**Attachment 1 - St. Lucie NRC Examination Facility Comments**

Question 32

# SIMPLIFIED DRAWING OF MAIN STEAM (UNIT 2)

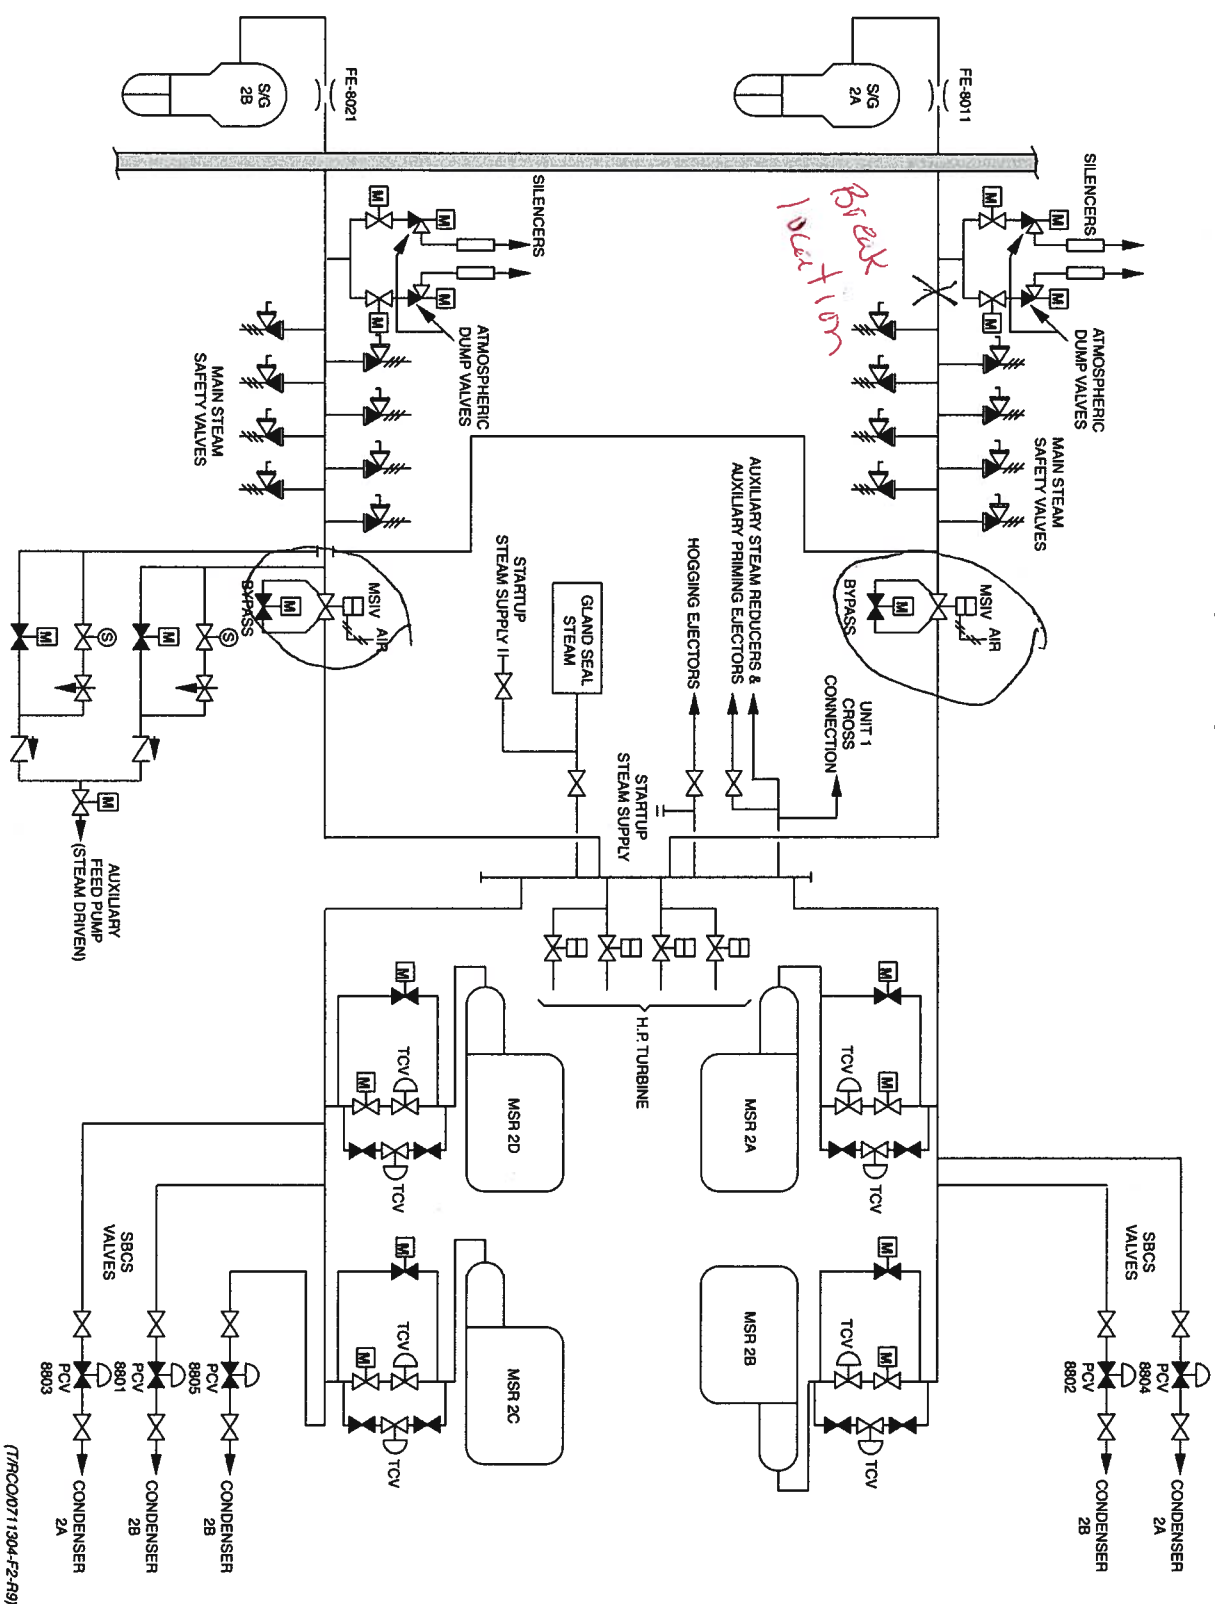
Given that SG pressures (plural) are 580 psia and rapidly lowering, this means that MSIS did NOT automatically actuate as designed at 600 psia. If it had actuated, then only the faulted steam generator pressure (2A) would continue to lower and the intact SG pressure (2B) would stabilize since the main steam line break was upstream of the 2A SG MSIV (refer to attached drawing).

Since MSIS did not actuate automatically as designed at 600 psia, the operators must manually actuate MSIS in addition to SIAS.

**FPL Utility Position:** Based on the above discussion, change correct answer to "C" instead of "D".
